APPLICATION FOR AN AMENDMENT TO LICENCE L5529/1988/12 UNDER THE ENVIRONMENTAL PROTECTION ACT 1986 – NOTICE OF DECISION TO GRANT

Licence Number	L5529/1988/12
Licensee	Mt Magnet Gold Pty Ltd
ACN	008 669 556
Registered business address	Suite 4, 148 Greenhill Road PARKSIDE SA 5063
Date of amendment	30 June 2017
Prescribed Premises	Category 5: Processing or beneficiation of metallic or non-metallic ore Category 6: Mine dewatering Category 64: Class II putrescible landfill site
Premises	Mt Magnet Gold Mining Tenements M58/121, M58/193 and M58/205, MOUNT MAGNET WA 6623

Amendment Notice

This notice is limited only to an amendment to include the dewatering of the St George pit and St George and Water Tank Hill underground workings with discharge to the Ruby Queen pit, dewatering of the Titan pit with discharge to the Saturn pit, and to incorporate relevant *Administrative Changes implemented within the Department of Environment Regulation* (Administrative Changes).

Map of emission points

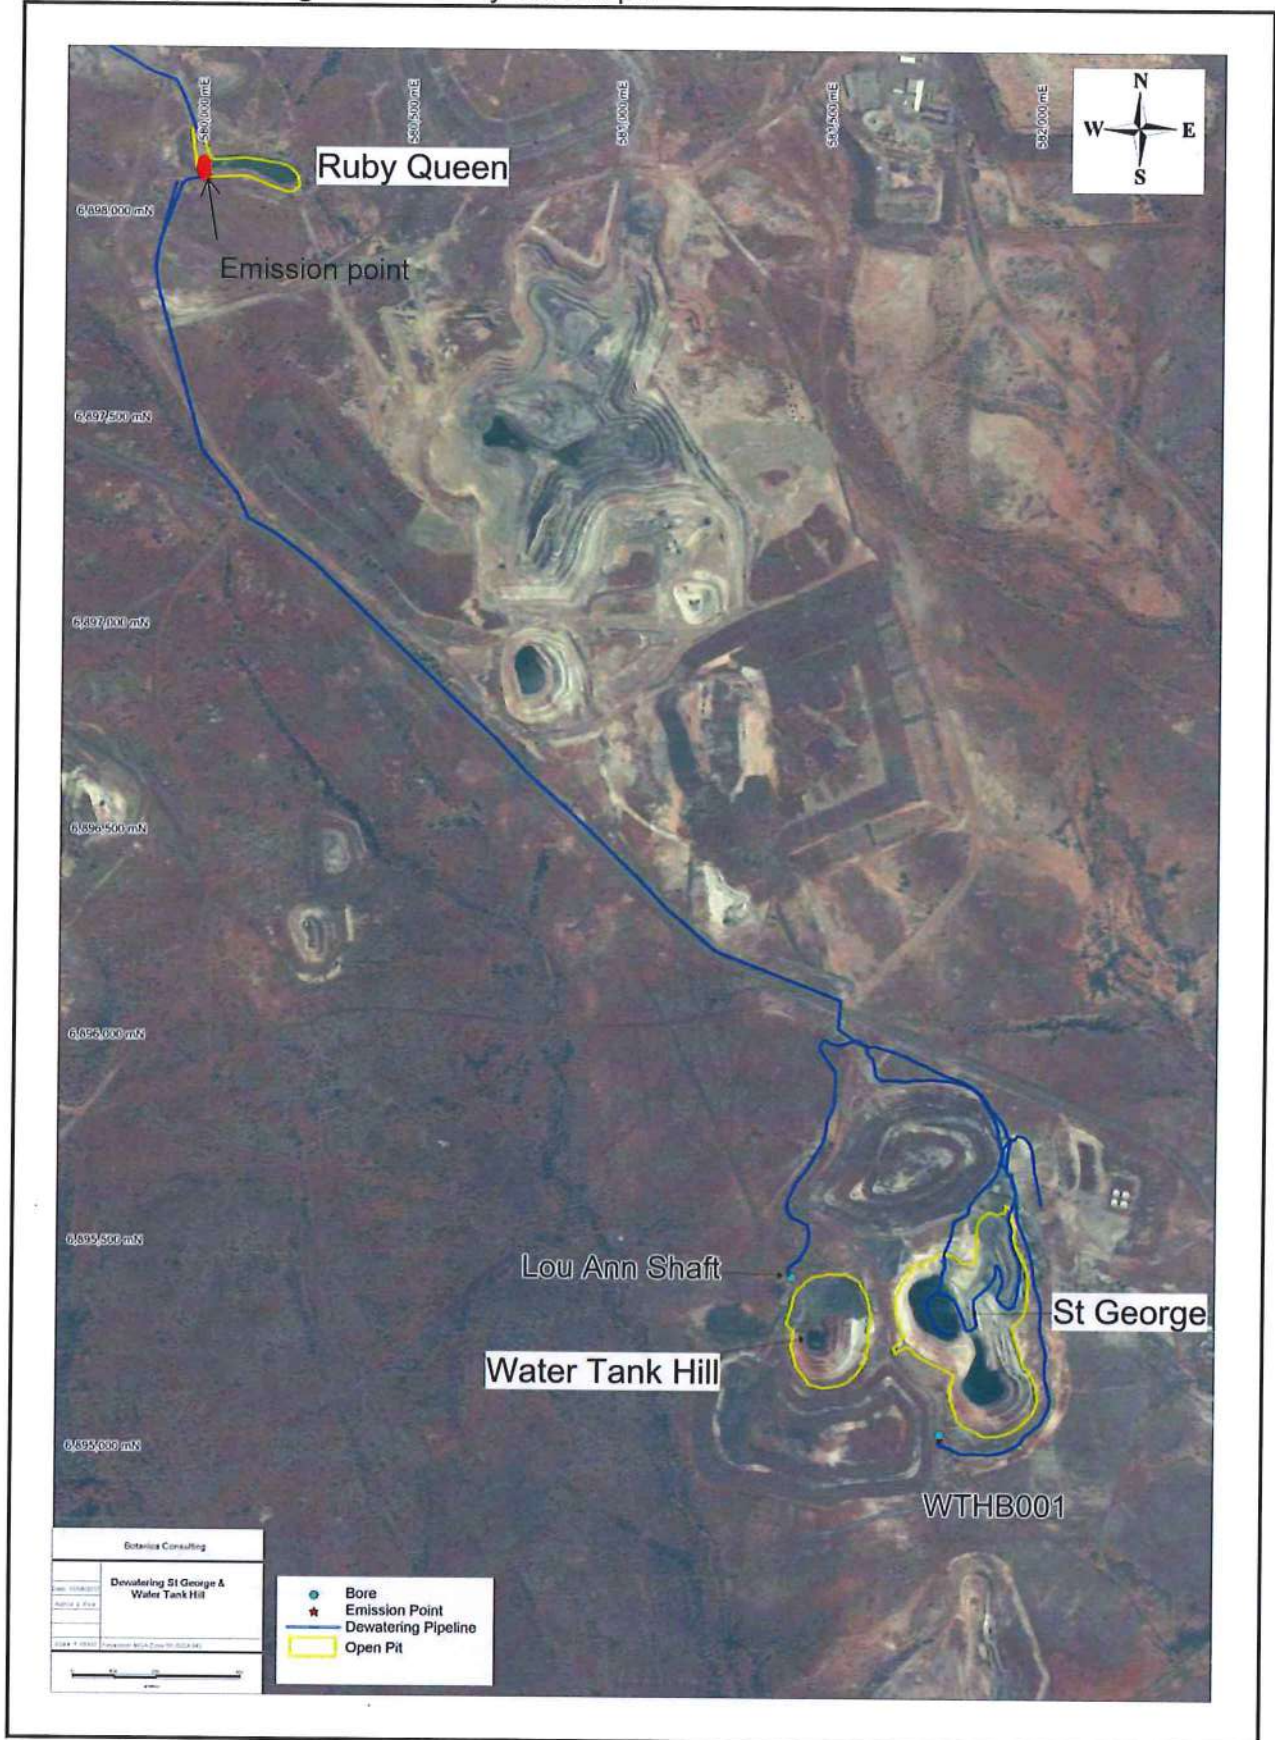
- Removal of the map of emission points defined in Table 2.2.1 and replace with updated maps to show the new emission points;
- Removal of the map of monitoring locations defined in Table 3.2.1 and replace with updated maps to show the new monitoring locations; and

7. The licence is amended by the removal of the Annual Audit Compliance Report template in Schedule 2.
8. The Licence is amended by removing the map in Schedule 1 Map of emission points and insertion of the maps below:

The location of the emission points defined in Table 2.2.1 are shown in the maps below.

Dewatering discharge to the Saturn pit

Dewatering discharge to the Ruby Queen pit

Map of monitoring locations

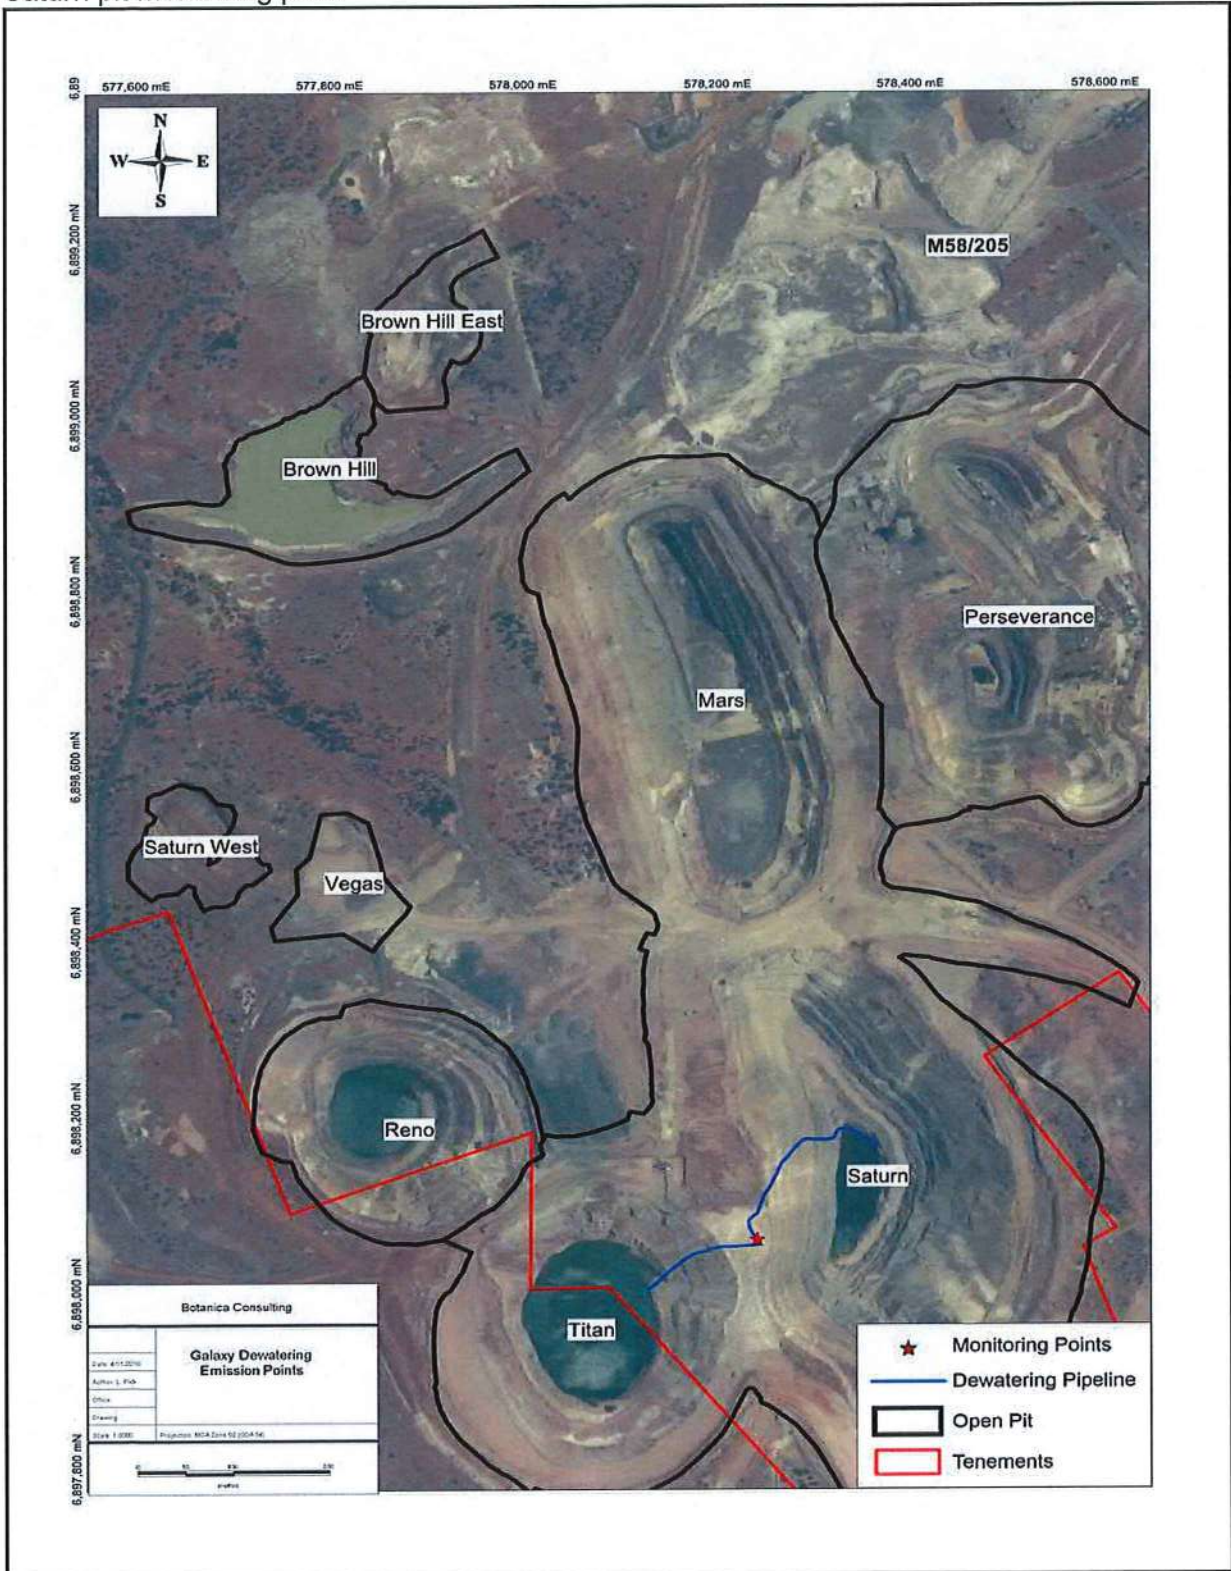
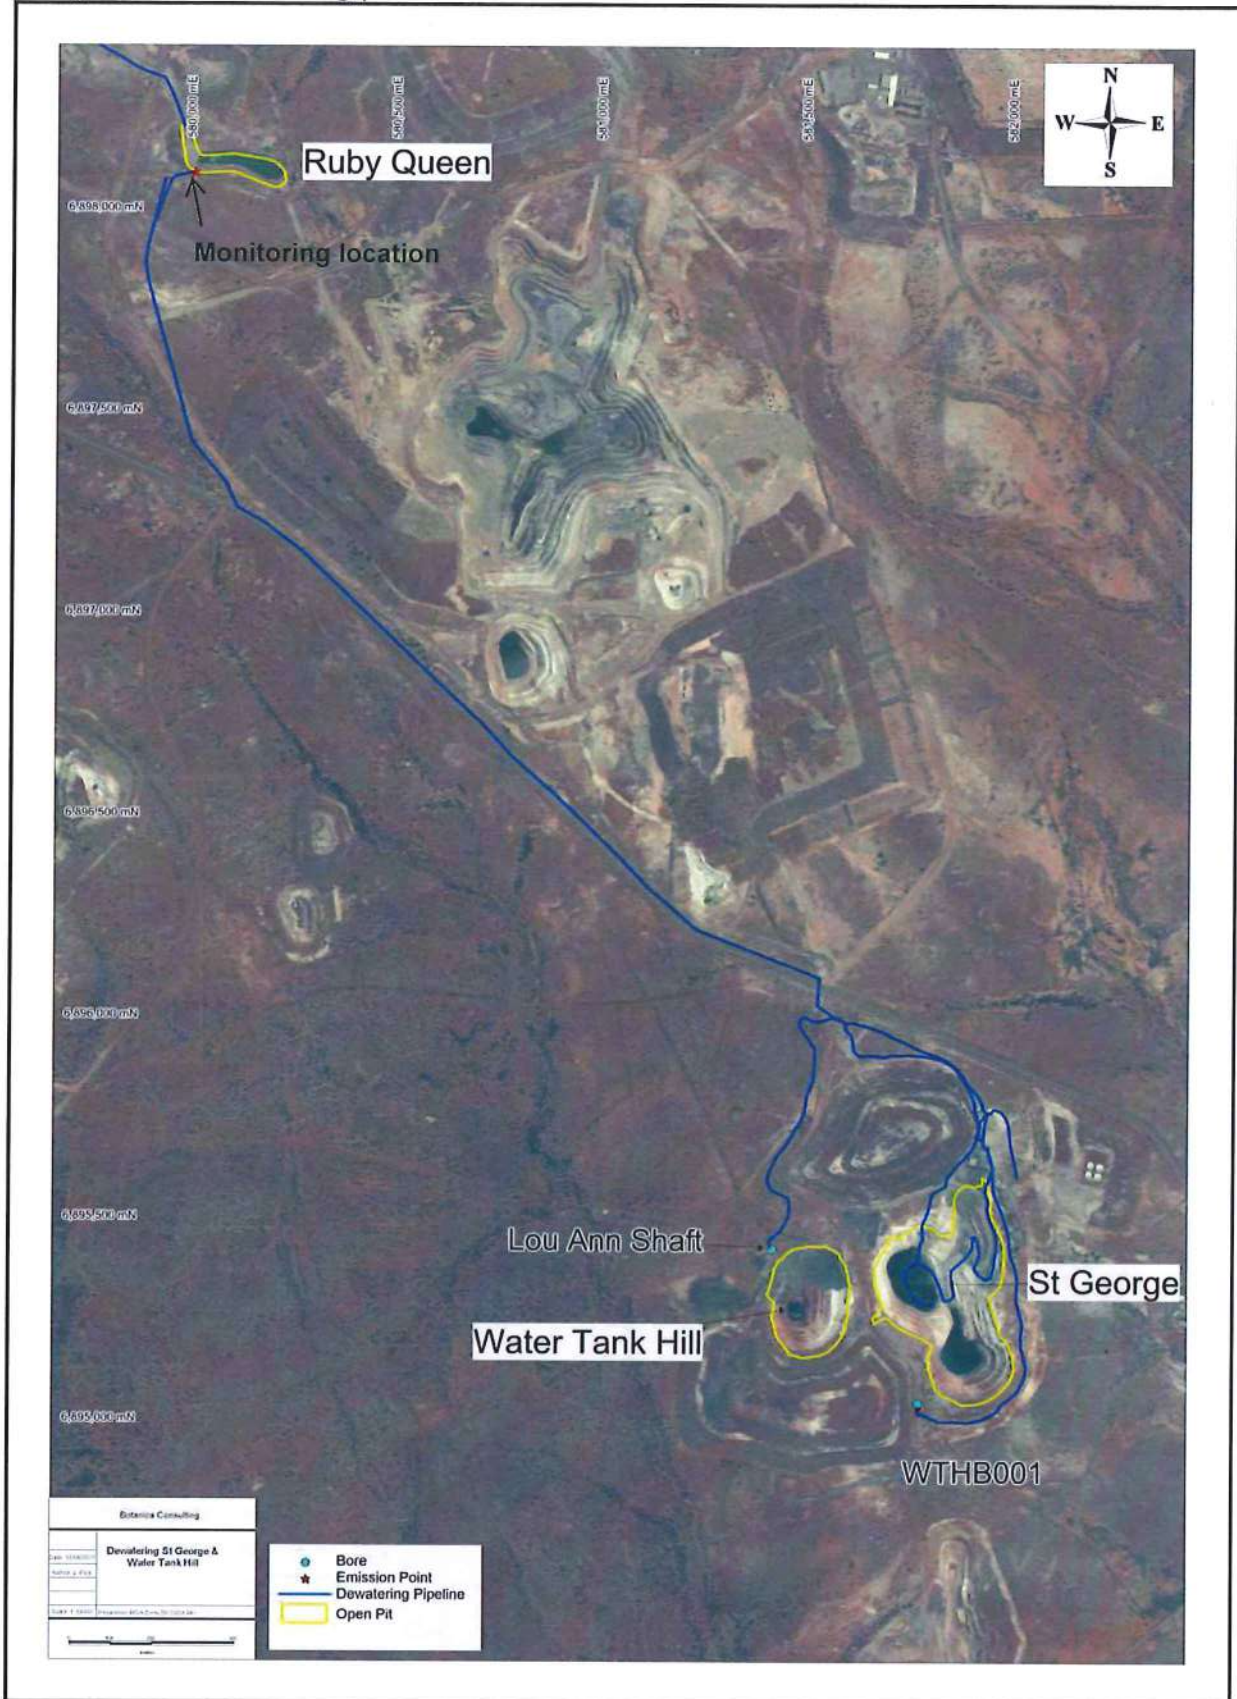
9. The Licence is amended by removing the map in Schedule 1 Map of monitoring locations and insertion of the maps below:

The locations of the monitoring points defined in Table 3.2.1 are shown below.

Saturn pit monitoring point

Ruby Queen monitoring point
